REQUEST

Current Zoning: R-3 LLWPA (single family residential, Lower Lake Wylie Protected Area)
Proposed Zoning: B-1(CD) LLWPA (neighborhood business, conditional, Lower Lake Wylie Protected Area)

SUMMARY OF PETITION

The petition proposes to allow up to 10,000 square feet of neighborhood services and retail uses, including fuel sales, and tree save on 2 vacant lots located in northwest Charlotte, east of I-485.

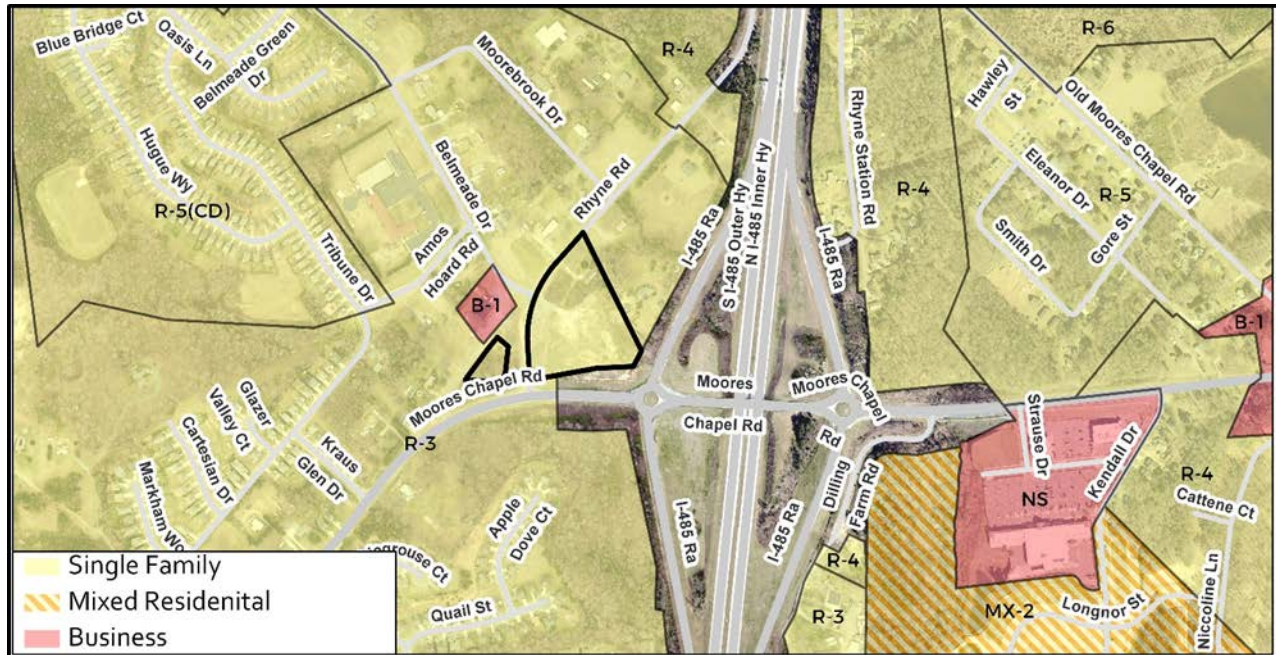
The site plan accompanying this petition contains the following provisions:

- Proposes up to 10,000 square feet of neighborhood services and retail uses as allowed in the B-1 zoning district.
- A 6,600-square foot building with 3 drive through windows.

- Fuel canopy with 40 8 fuel stations.
- Future development area identified in northern portion of the rezoning site. Notes future development may include office, retail or other neighborhood services.

- A 43-foot wide Class B buffer along property line abutting acreage zoned R-3.
- Commits to the following transportation improvements:
 - Proposes to utilize driveways connecting to Rhyne Road on the northern edge of the site and to Rhyne Road via a right-in only driveway as shown on the site plan and subject to approval by NCDOT or CDOT, whichever has jurisdiction.

- Illustrates proposed future back of curb 26 feet as measured from centerline along Rhyne Road, and proposed future back of curb 42 feet as measured from centerline.

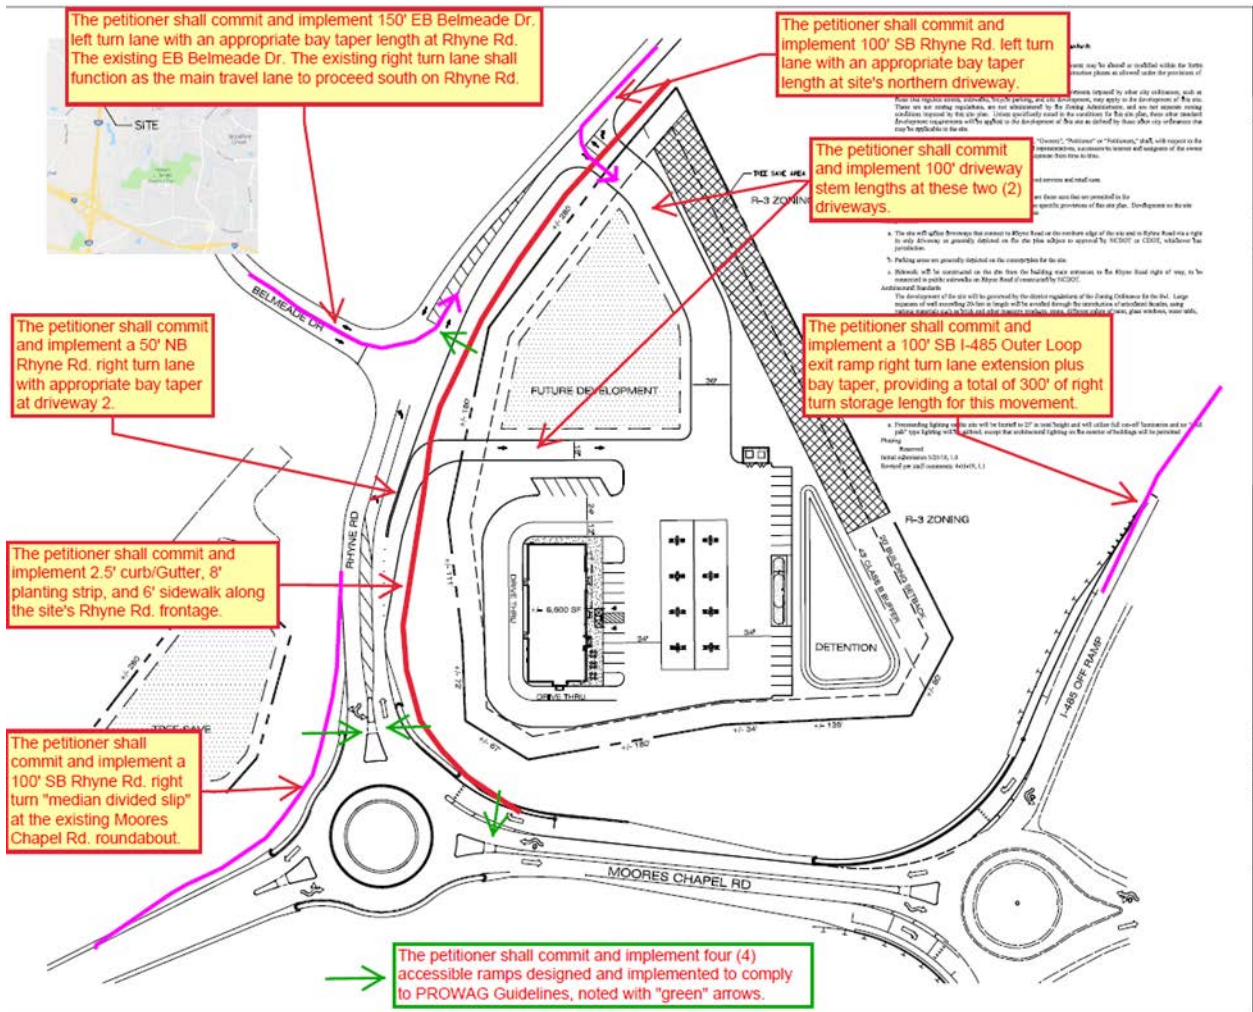
1. The proposed zoning district has a setback measured from back of the existing or proposed future curbline. The future back of curb locations are as follows:

- b. Rhyne Road is designed as a 3-lane divided avenue adjacent to the site. The proposed future back of curb is 26' (5.5' (1/2 left turn lane) + 12' travel lane + 6' bike lane + 2.5' curb/gutter from its centerline. CDOT is recommending specific streetscape improvements including implementing curb/gutter improvements along the site's Rhyne Road frontage.

6. The petitioner should revise the site plan to add conditional notes to commit to implement 4 accessible ramps along the site's Rhyne Road frontage per exhibit depicting all current transportation improvements required.
